Re: Modification of Coal Hollow Mine (CHM) Pit 10 Drainage Controls on Drawings 5-3B & 5-3C, Alton Coal Development, LLC, Coal Hollow Mine, Kane County, Utah, C/025/0005

Permittee: Alton Coal Development, LLC
Mine: Coal Hollow Mine **Permit Number:** C/025/0005
Title: Pit 10 Drainage Controls

APPENDIX 5-2

Sediment Impoundment and
Diversion Structure Analysis

DRAWING: 5-3B

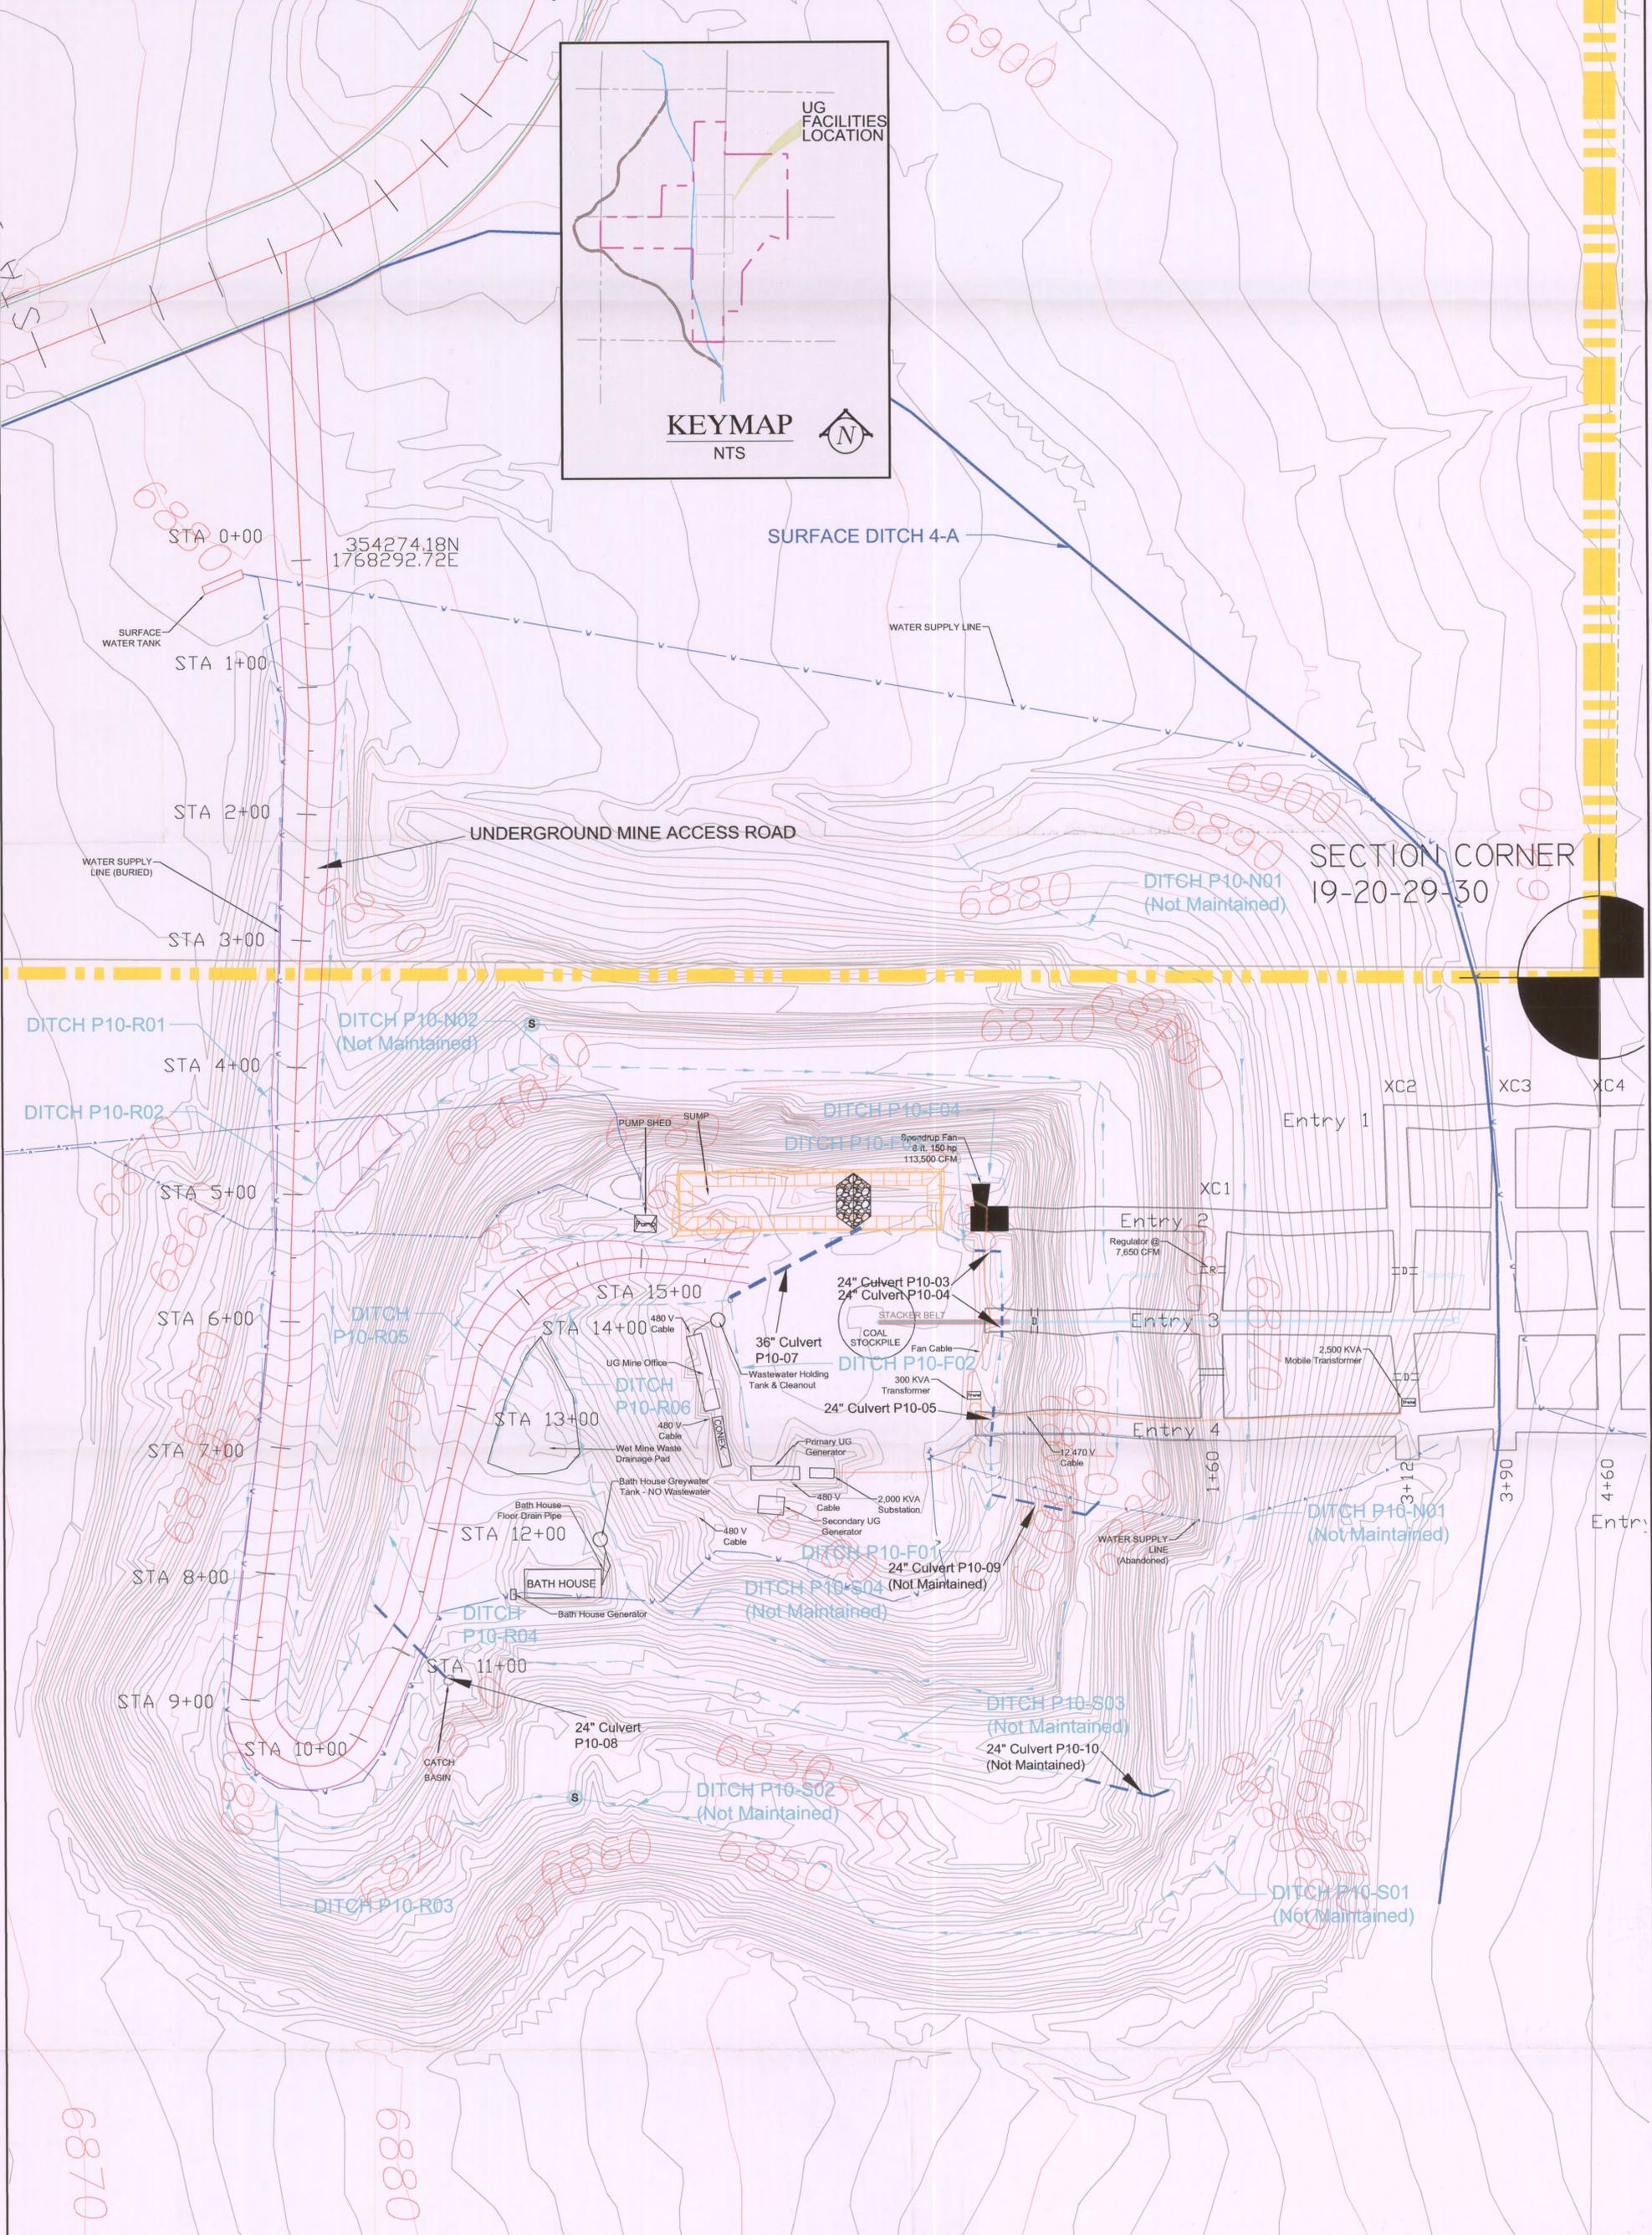
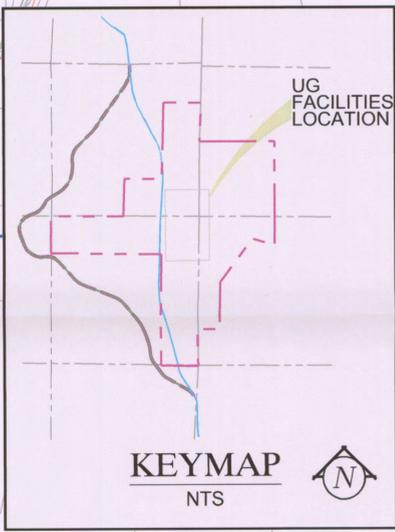
Alton Coal Development, LLC (ACD) is submitting an amendment to the MRP to update and modify the maintenance protocols for several drainage controls in Pit 10 shown on Drawings 5-3B and 5-3C. These modifications are necessary to ensure the safety of mine workers and to eliminate the potential for employees or equipment to be in an area where rockfall or slough hazards exist.

ACD asserts that the sediment load transported to sediment pond #3 (which in itself is a UPDES permitted sediment control and discharge structure) can continue to be sufficiently minimized by ongoing maintenance of the pit-bottom sump without having to place equipment and personnel in hazardous areas by performing maintenance of the channels on the highwall or spoil slopes. Therefore, Drawings 5-3B and 5-3C have been modified to show drainage channels located on the highwall, highwall bench and spoil slopes as being unmaintained. Drawing 5-3C also shows the modified configuration of the pit-bottom sump to allow room for sloughed material while maintaining the required capacity.
